Re: Final Summary Report, Roan Creek Evaporation Pond

The Colorado Oil and Gas Conservation Commission (COGCC) requested that Burns & McDonnell review a produced water evaporation pit permit application and associated documents for the Roan Creek Evaporation Pond submitted by the permittee, Maralex Resources, Inc. (Maralex). Maralex has requested to use an existing pond under a new Centralized E&P (Exploration and Production) Waste Management Facility permit (Form 28). COGCC also requested Burns & McDonnell to provide an independent opinion regarding the suitability of the existing liner for long term future use. This letter report has been prepared to present our independent opinion.

Photograph 6: View of deteriorated Panel 14 along north side of pit. Note the holes and patches are all generally located at or below the high water mark.

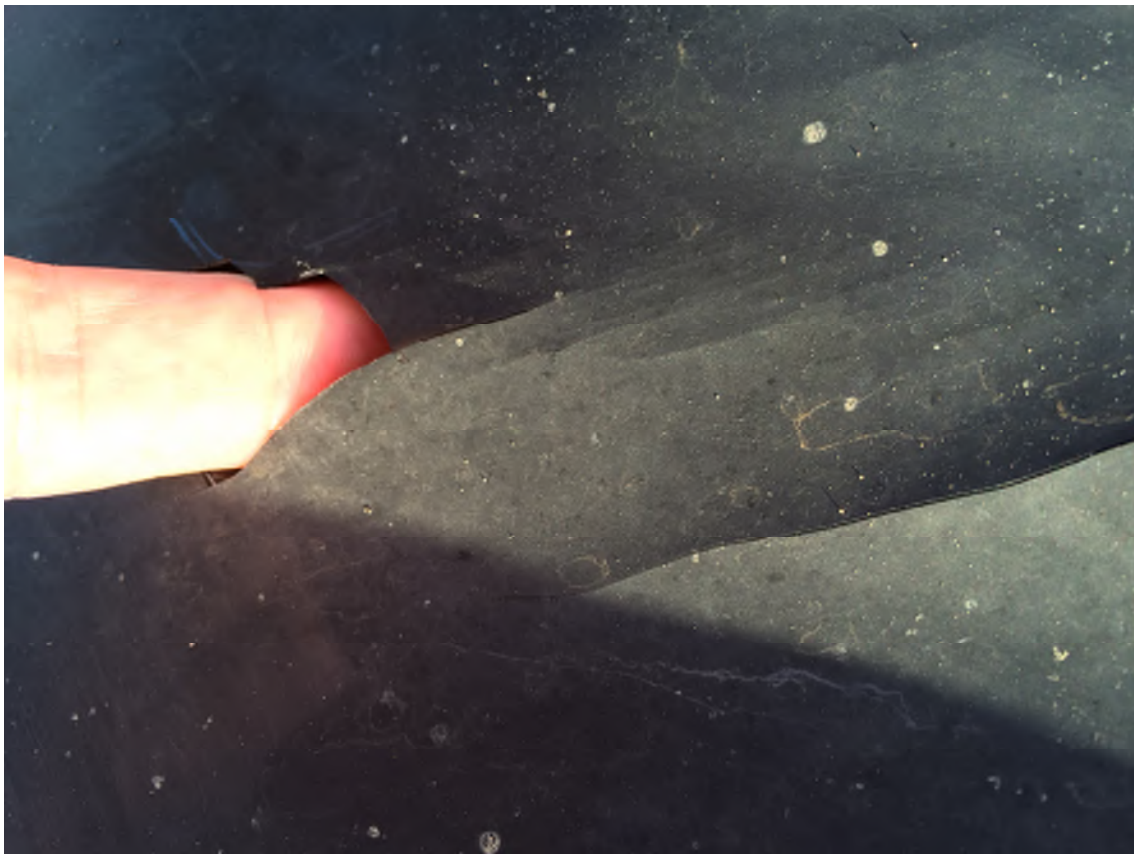
Numerous non-industry standard geomembrane patches were observed at several locations along the pond side slopes. Some were extrusion welded and some were not. Some of the patches utilized HDPE and some didn't. Some extrusion welds appeared to be professionally made to industry standards while others appeared to be of poor quality done by poorly trained and/or equipped technicians. Some patches were only partially welded. Most holes outside of Panel 14 had been marked for repair. Also some additional holes were observed (see Photographs 8 and 9).

1. It is suspected that something in the pond contents, possibly hydrocarbons, *may* have leached the carbon black from the geomembrane and made the geomembrane more susceptible to ultraviolet ray deterioration, resulting in the brittleness and cracking beneath the high water mark. If this theory is correct, all the panels are deteriorating – not just Panel 14. Panel 14, which is oriented with a southern aspect, receives the most sunlight and thus is just deteriorating at a faster pace than the other panels.

It is Burns & McDonnell's opinion, based on the data reviewed and observations described above, that Panel 14 cannot be simply replaced and the remaining identified holes repaired and the liner meet the requirements of its planned future use or life expectancy. This is exemplified by TRI's remark that "degradation is likely in the next few months and years". We do have the following recommendations:
